Dealer Service Instructions for:

Equipment Safety Recall W26

NHTSA 20E-020

Bed Step

Figure 1 – Old Bed Step Brace

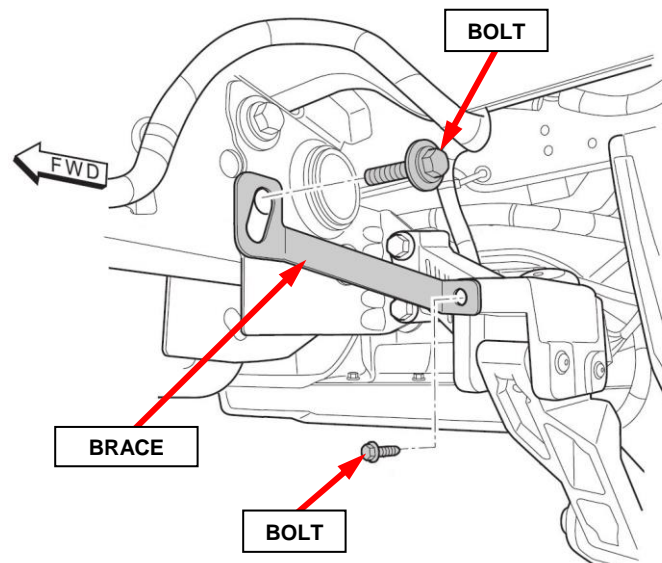
2. Remove and **DISCARD** the two bolts securing the bed step brace (Figure 1).

3. Remove the recalled bed step brace then render it unusable and **DISCARD**. (Figure 1)

Figure 3 – New Bed Step Brace

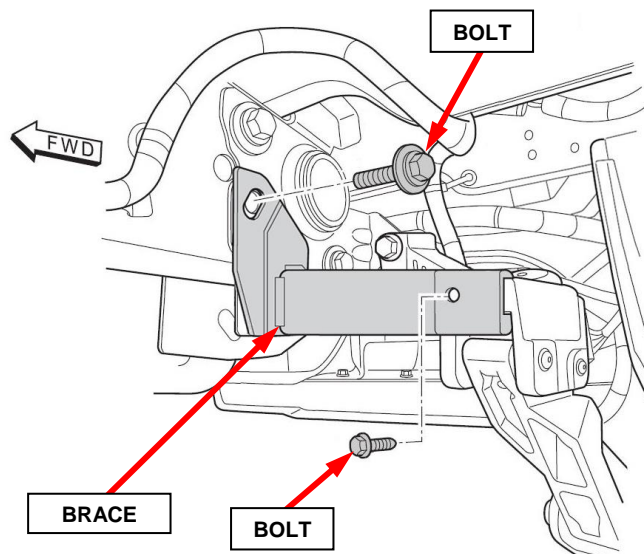
5. Install the **NEW** bed step brace (Figure 3).

6. Loosely install the **NEW** M8 bolt then the **NEW** M16 bolt included in the campaign kit (Figure 3).

Figure 4 – Bolt Tightening Sequence

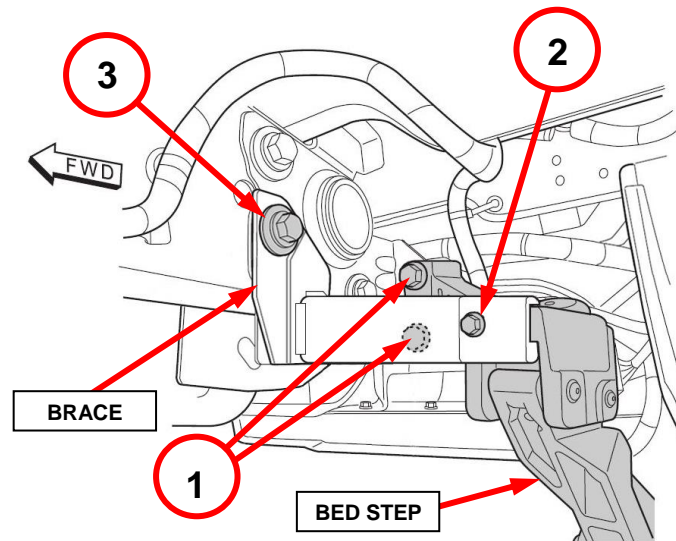
7. Tighten the bolts in the following sequence (Figure 4):

NOTE: After tightening the bed step bolts (1) and before tightening the bracket bolts (2, 3) check for clearance between bed step and bumper with bed step in the stowed position. Adjust as necessary to avoid any contact.

- (1) M10 bed step bolts.
68 N·m (50 ft. lbs.)
- (2) M8 brace bolt.
22.5 N·m (16.5 ft. lbs.)
- (3) M16 brace bolt.
190 N·m (140 ft. lbs.)
